Access Compliance Report

Public Rights-of-Way

(Curb Ramps)

Intersection ID: 15402	Main Street: MARSH_RD	Cross Street: NEW_BERN_ST	Location: NW
ADA ID: 1750838D6507	Ramp Type: Perp	Initial Pass/Fail: Fail	Overall Compliance: No Severity Score: 13.75

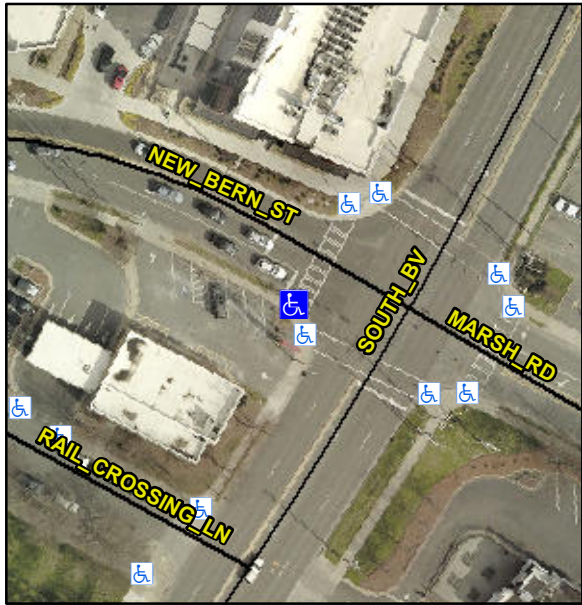
Codes/Mitigation Info/Possible Solution			Field Measurements/Component Compliance					
	Possible Solutions:		Compliance	Description	Data	Compliance	Description	Data
	Remove & Replace Entire Ramp.		N/A	Ramp Length (in)	25.0	No	Ramp Slope (%)	8.6
			Yes	Ramp Width (in)	48.0	No	Ramp XSlope (%)	2.8
			N/A	Flare Type LT	N/A	N/A	Flare Type RT	N/A
			N/A	Flare Slope LT (%)	N/A	N/A	Flare Slope RT (%)	N/A
			N/A	Flare Traversable LT?	N/A	N/A	Flare Traversable RT?	N/A
			N/A	Landing Length (in)	N/A	N/A	DWS Provided?	N/A
			N/A	Landing Width (in)	N/A	N/A	DWS Contrast?	N/A
			N/A	Landing Slope (%)	N/A	N/A	DWS Length (in)	N/A
			N/A	Landing X Slope (%)	N/A	N/A	DWS Full Width?	N/A
Surveyor Notes:			N/A	Landing Curb? (Y/N)	N/A	N/A	DWS Offset (in)	N/A
PROW/ADA:			Not Found, R304.2.2, R304.5.3	Shared Landing?	N/A			
				Gutter Ponding?	N/A	N/A	Gutter Slope (%)	N/A
				Gutter Lip Ht (in)	N/A	N/A	Gutter X Slope (%)	N/A
				Painted X Walk1?	Yes	N/A	Painted X Walk2?	N/A
